- I. PUD2022-101 & EA2022-122 The Terraces at Queensgate South

**CITY OF RICHLAND DEVELOPMENT SERVICES DIVISION
STAFF REPORT TO THE HEARING EXAMINER**

PROPOSAL NAME: The Terraces at Queensgate South – Planned Unit Development

PROJECT TYPE: Type 3A Preliminary Planned Unit Development

PP02

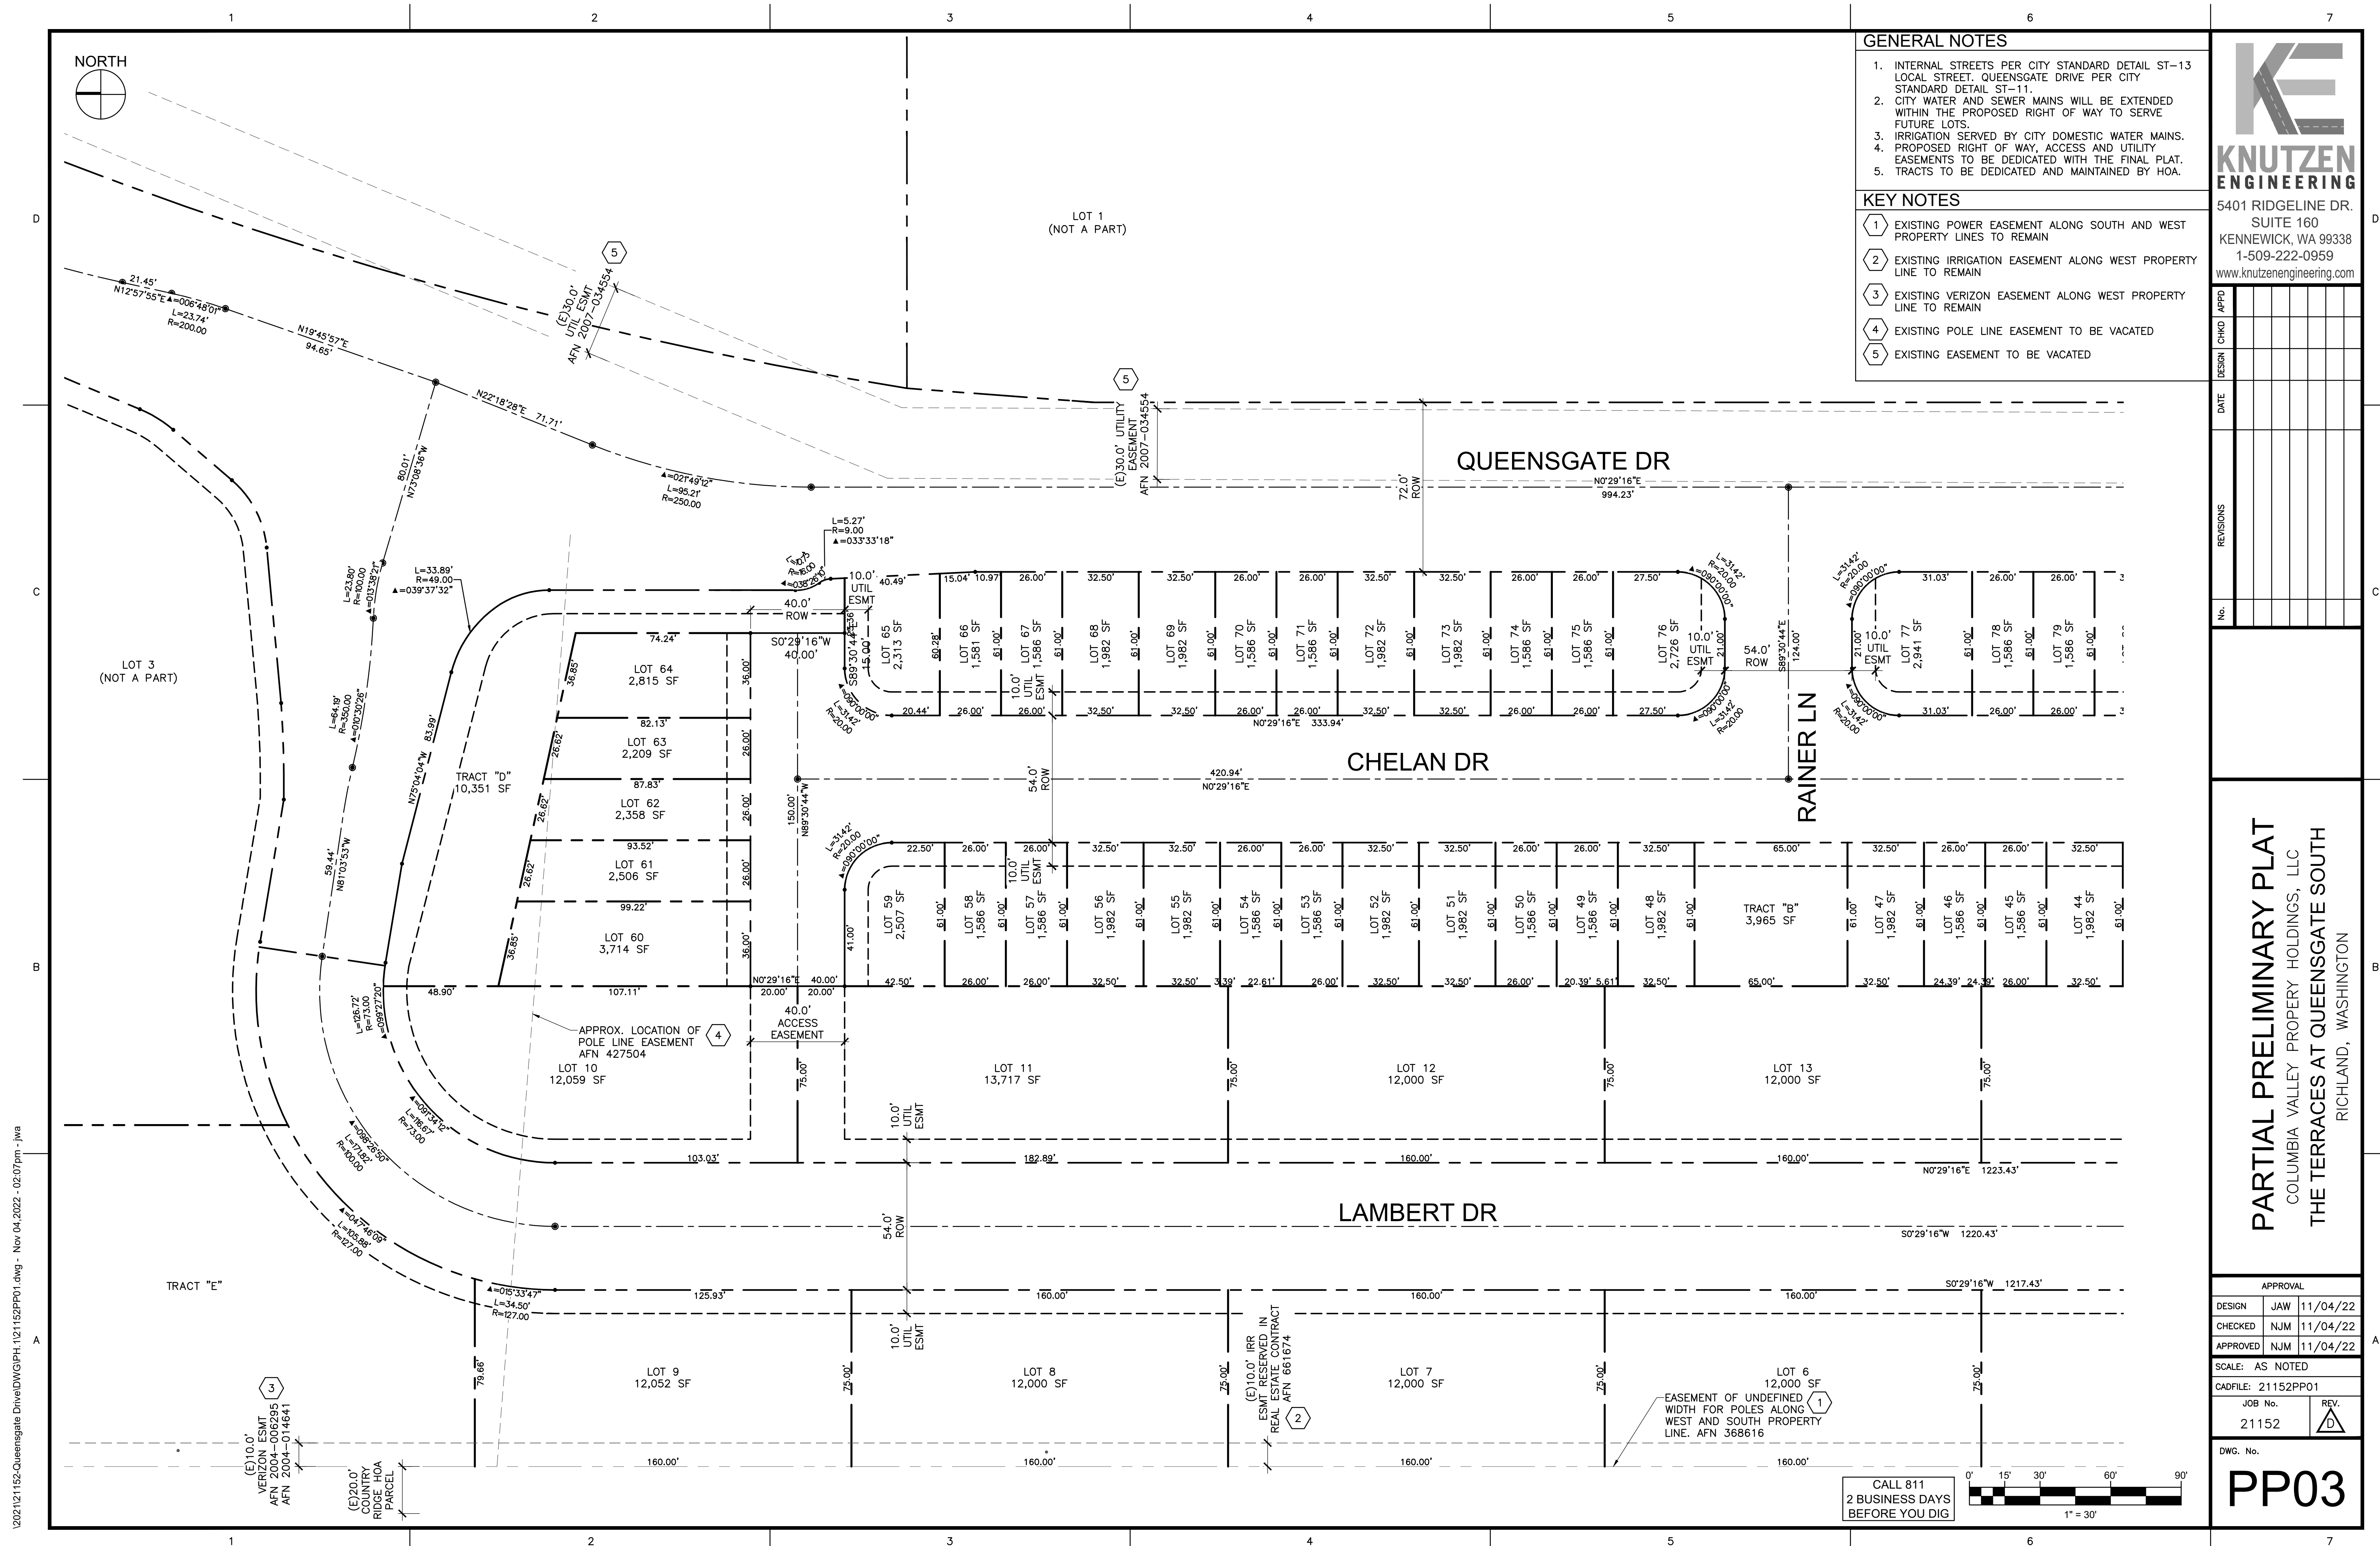
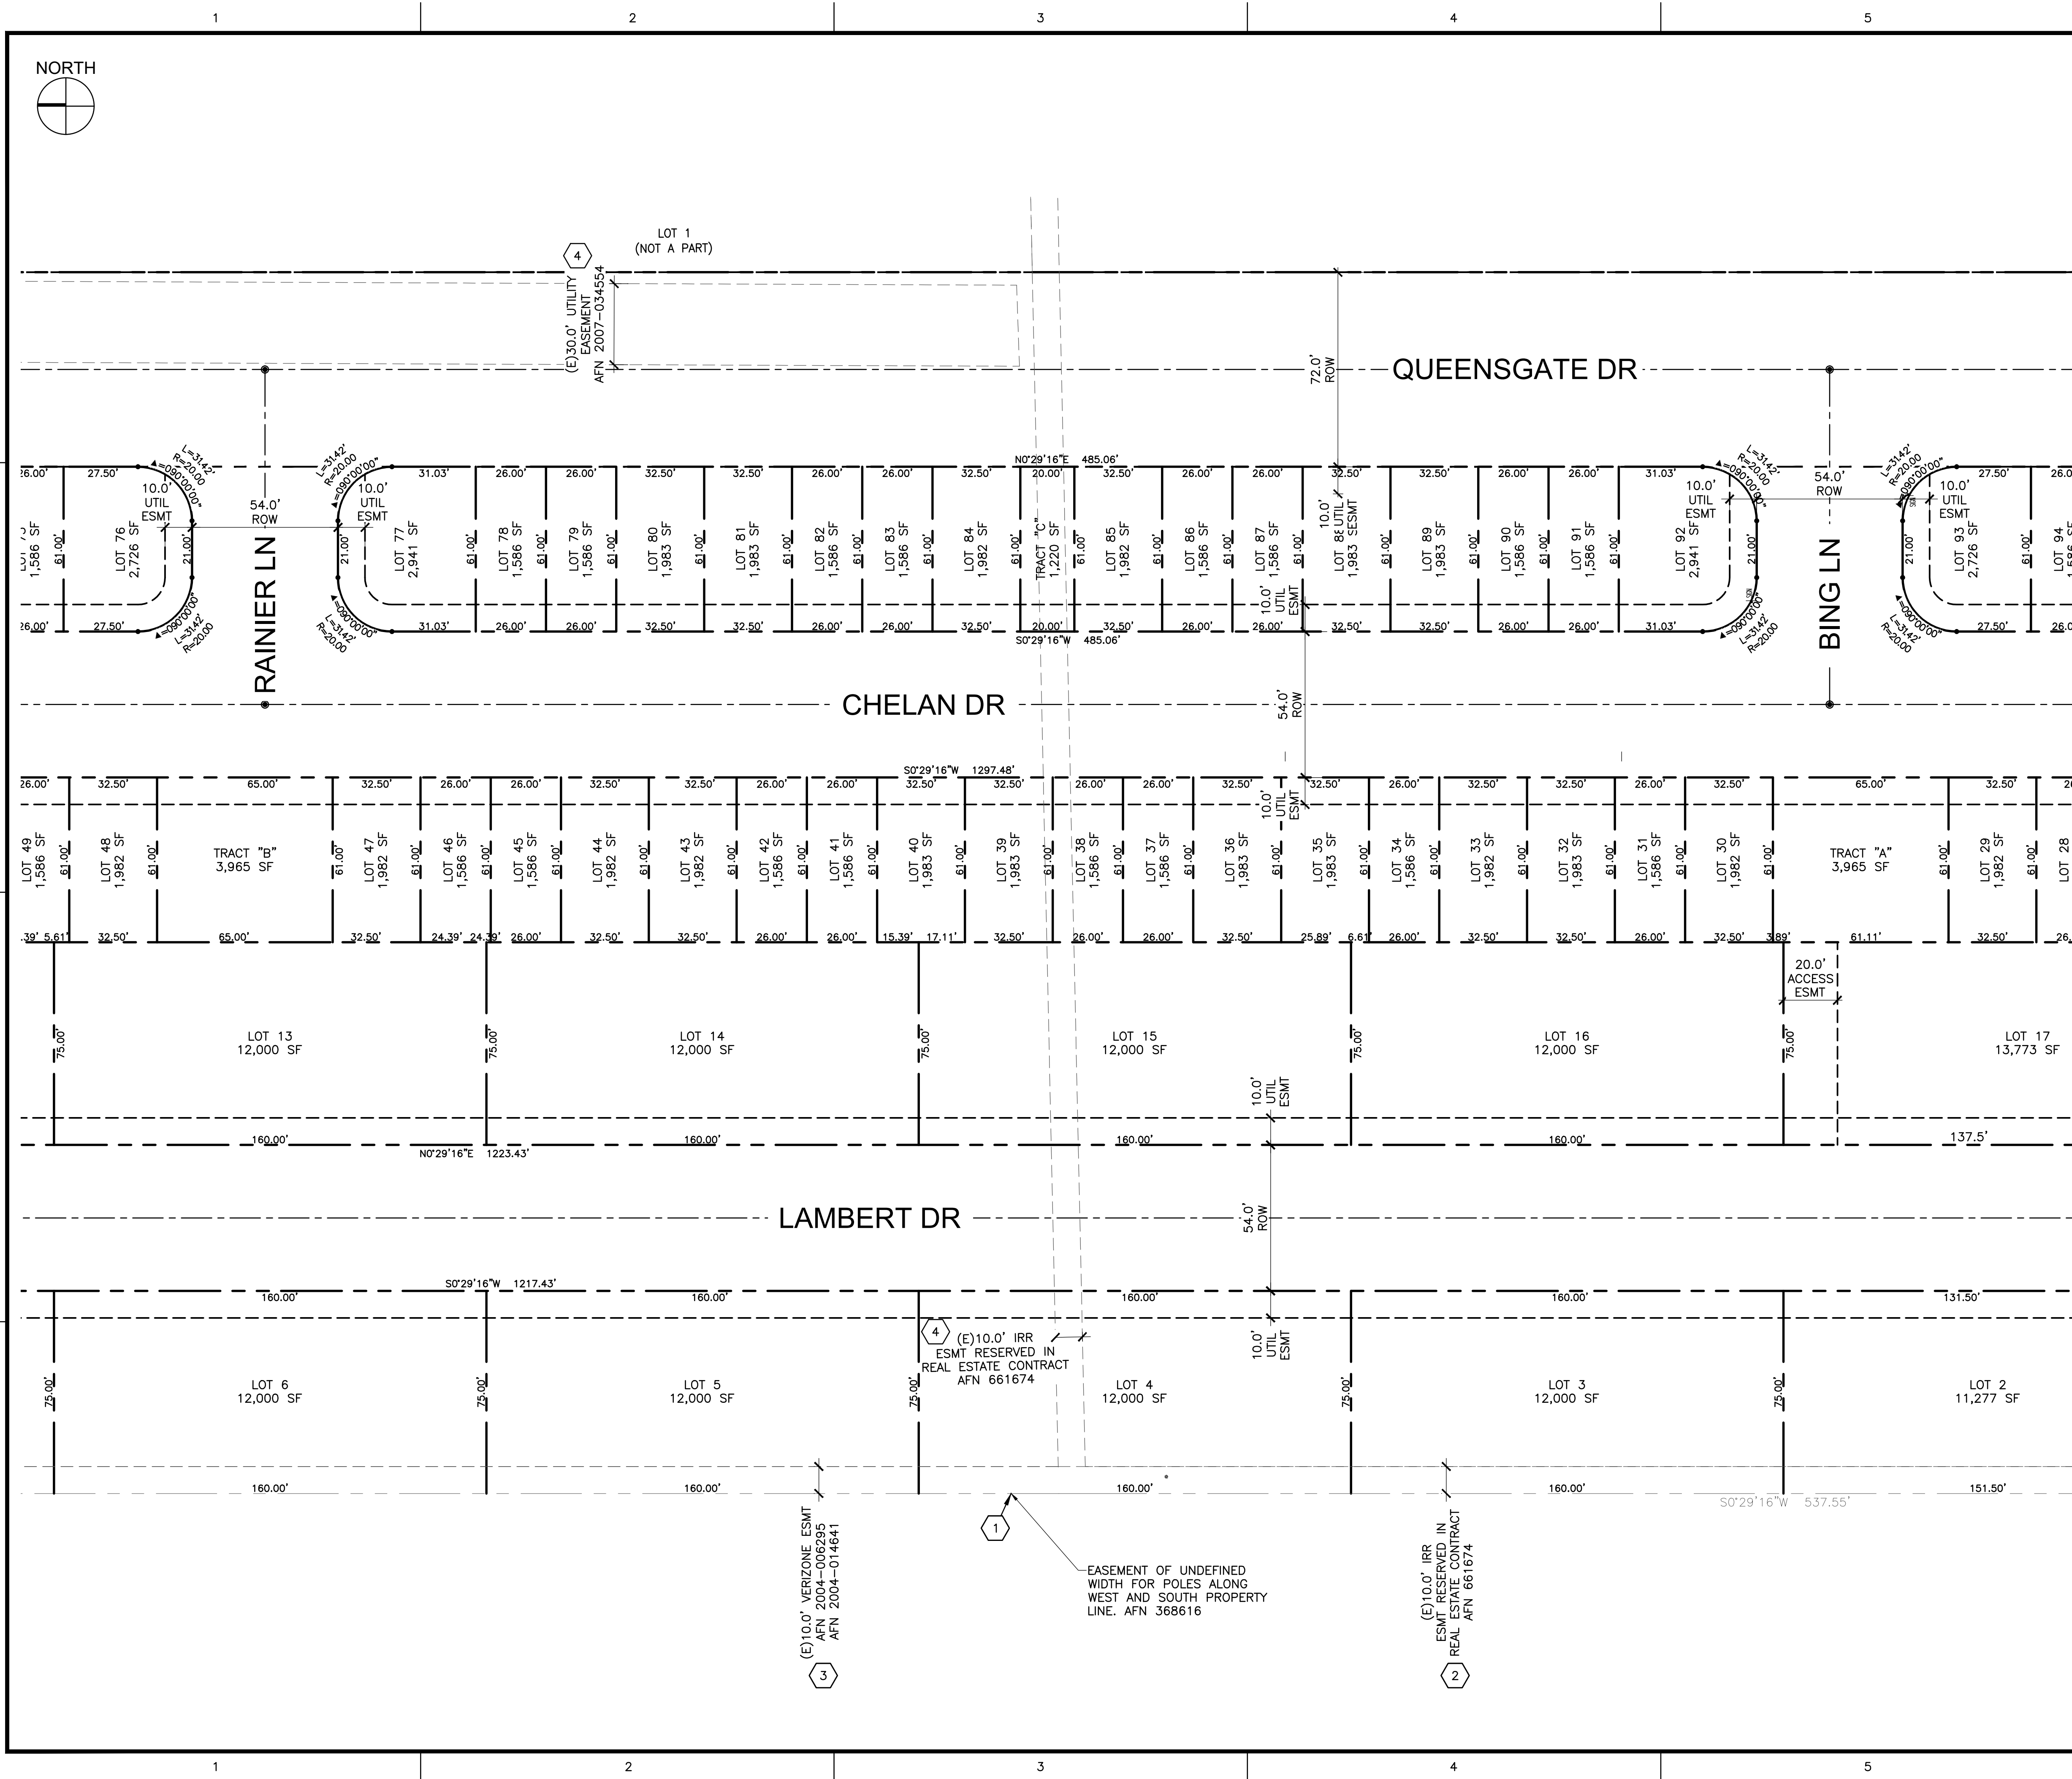
1. The limits (boundary) of this phase are not clearly depicted on the pre-plat map and need to be. Please provide a clear border of Phase 1.

22. The “Lambert Drive” right-of-way can be narrowed to 54-feet and does not have to be 60-feet wide as shown on sheet PP05.
23. Per city standard details, a 5-foot-wide separated asphalt pedestrian pathway shall be provided adjacent to all rural section roadways.

26. The centerline radius of “Lambert” Drive is depicted as 47-feet (Sheet PP05 of the pre-plat). This needs correction as per Richland Municipal Code the minimum centerline radius for a local street is 100-feet. Alternatively, the applicant can construct a city standard “Local Street Right Angle Intersection” at this curve.
